NAME: STONEFIELD RIDGE

LOCATION: 6506 OLD SAUK RD

STAFF REPORT
DEPARTMENT OF PLANNING AND DEVELOPMENT - PLANNING UNIT
December 22, 1987

To: Bill Roberts, Planning Department
From: Daniel R. Stapay, Superintendent of Parks
Subject: Review Comments - Stonefield Ridge Plat

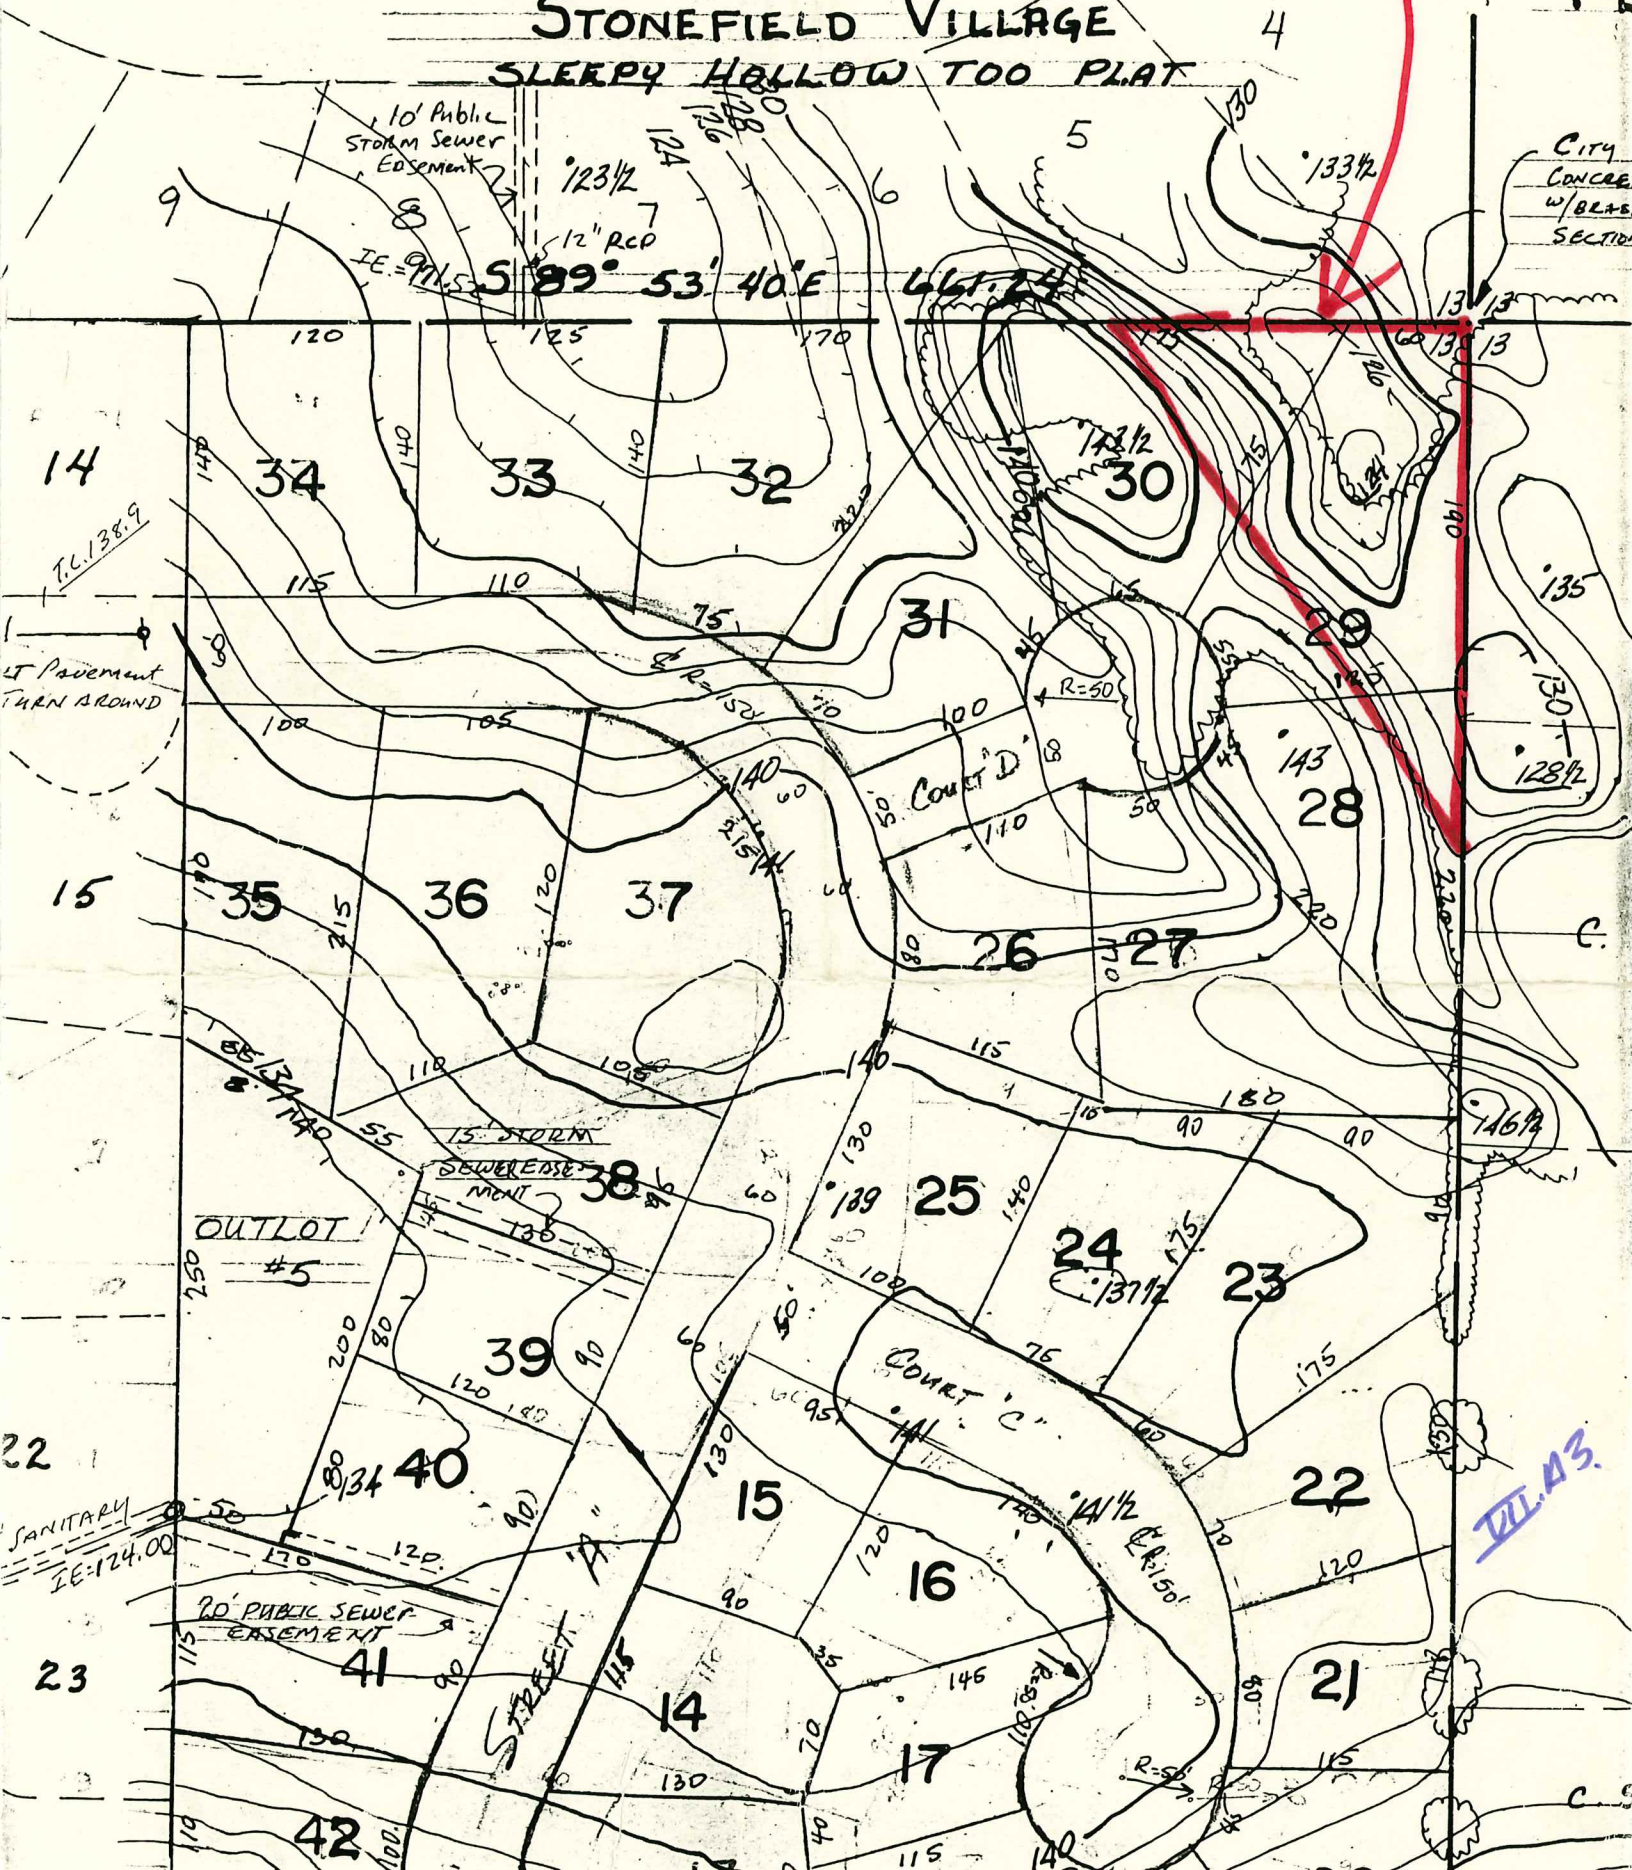
The proposed plat does not adequately preserve the wooded kettle hole in the northeast corner of the plat. The previously approved General Development Plan preserved this wooded area as a private conservation area. It should also be noted that the City of Middleton preserved lots 4 and 5 of the adjacent Stonefield Village Plat to protect their half of the wooded kettle hole.

Larger lots with a large no-development zone in the back would better protect the woods and steep topography and would be more compatible with the way similar land has been treated in the adjacent Highlands and City of Middleton developments.

Therefore we recommend that: Court D shall be replatted to provide larger lots with a no-building zone to protect the kettle hole and the 20 - 30% northeast slopes below elevation 140 (see attached sketch).
